Appendix 4c

Blackpool Council Licensing Service				
Representation made by a Responsible Authority in support of an application for the Review of a Premises Licence				
Responsible Authority making representation				
Name of Responsible Authority	Health and Safety			
Name of Officer <i>(please print)</i>	Marcus Maddock			
Signature of Officer				
Contact telephone number	01253 478341			
Date representation made	28	04	17	
Do you consider mediation to be appropriate			<u>YES</u>	NO
Premises Details				
Premises Name	Booze 101			
Address	101 Bispham Road			
	Blackpool			
	Lancashire			
Post Code	FY2 ONR			
Reasons for making representations				
<p>The health and safety section wish to make representation as part of the ongoing licencing review of 'Booze 101'. The inspection revealed several health and safety concerns which undermine the Public Safety objective of the Licensing Act.</p> <p>My colleague Jacqui Harrison and I visited the premises on 20th April 2017. During our inspection we found poor welfare facilities, in particular limited access to the hand washing stations, no hand soap and no means of hand drying. There was also an inadequate provision of hot water (a kettle type

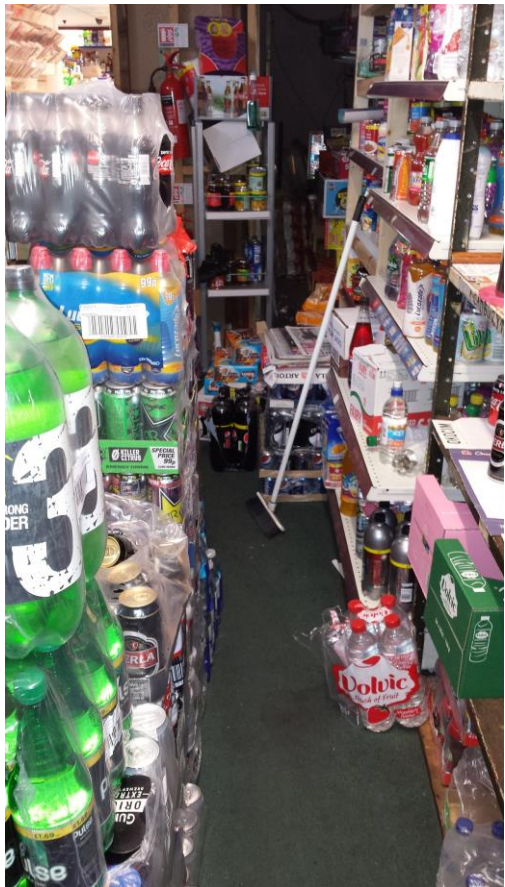
Picture showing 1 socket feeding 3 drinks fridges - under resourced in regards to electrical sockets. Overloaded electricity is a major cause of fire and this extension lead is next items that would easily combust if the socket or wires overheated.

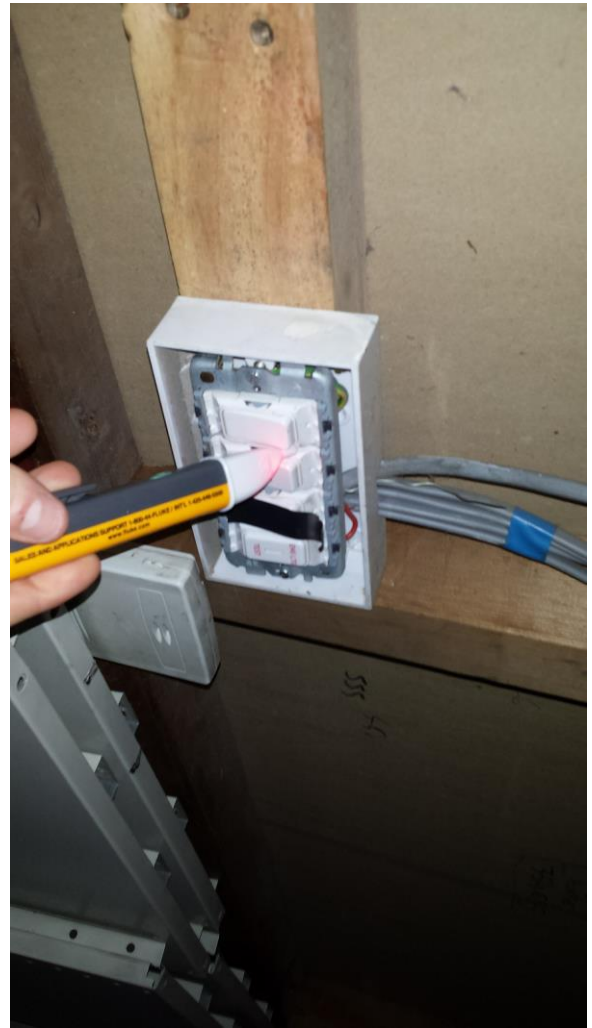
All 4 images showing the access and egress at the back of house. Traffic routes are heavily obstructed with stock. Picture on top right showing the stores emergency exit.

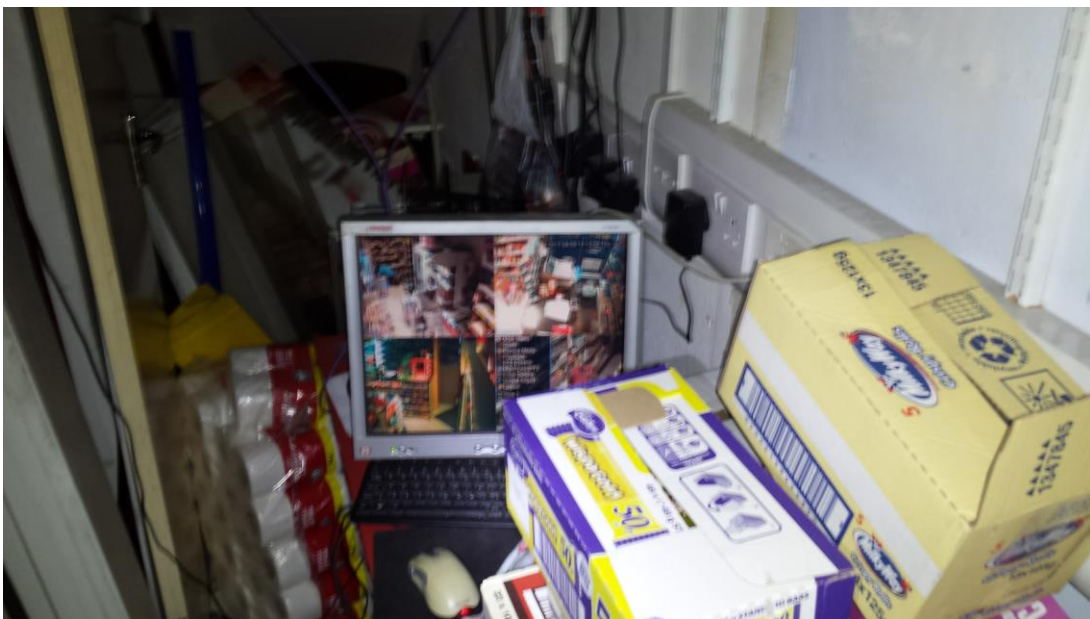
Picture on the left shows a bank of switches with the front casing removed. The picture on the right shows exposed live parts. A degree of protection should be provided so this contravenes Wiring Regulations 2008.

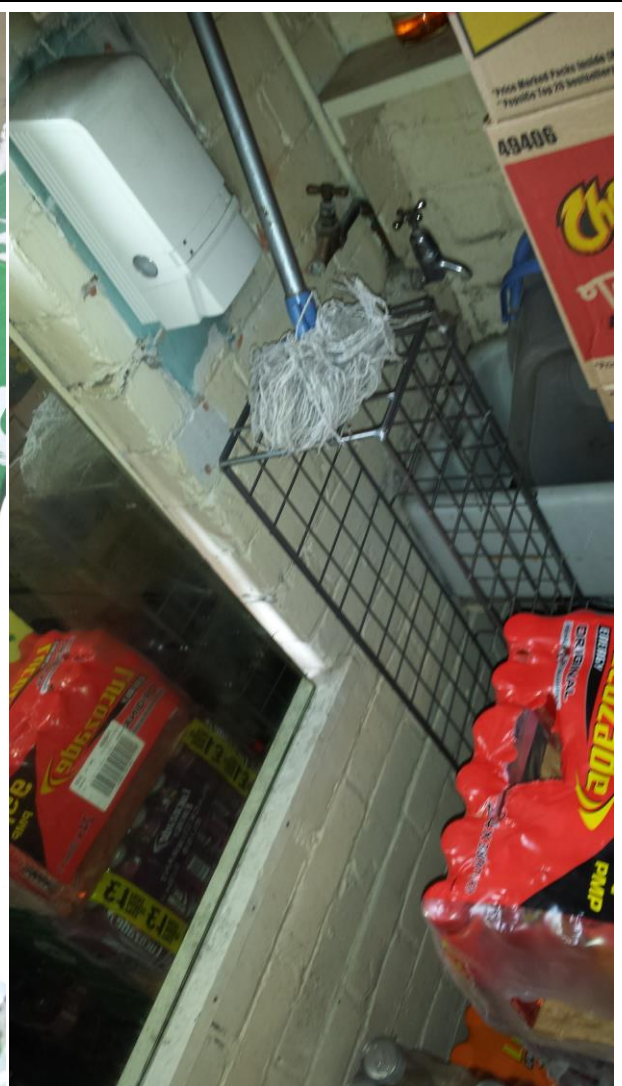
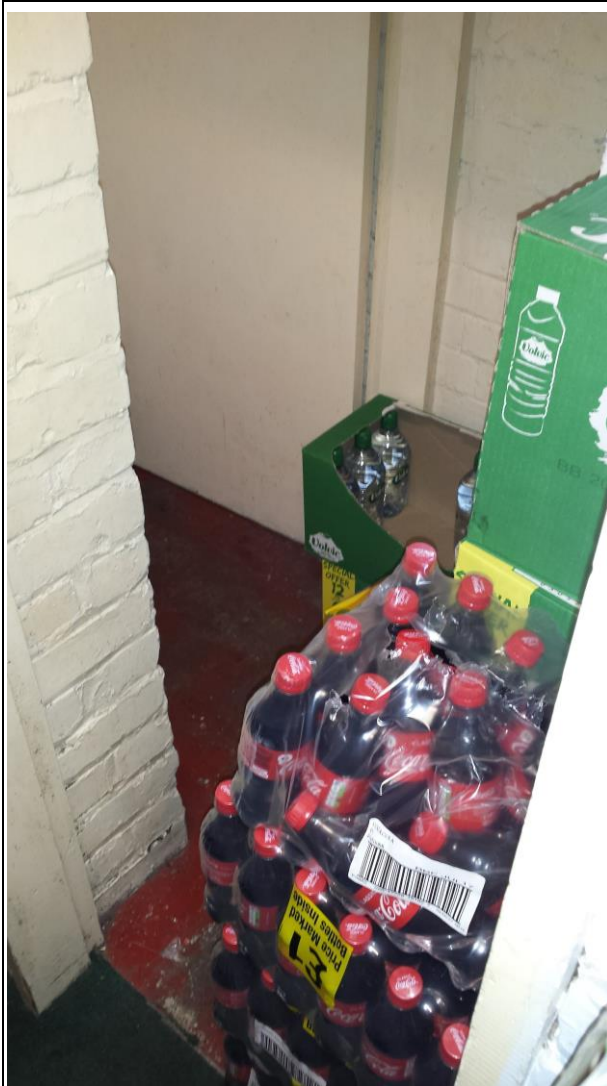
CCTV screen obstructed by excessive stock and empty boxes.

Another picture showing the walkway leading to the CCTV screen.
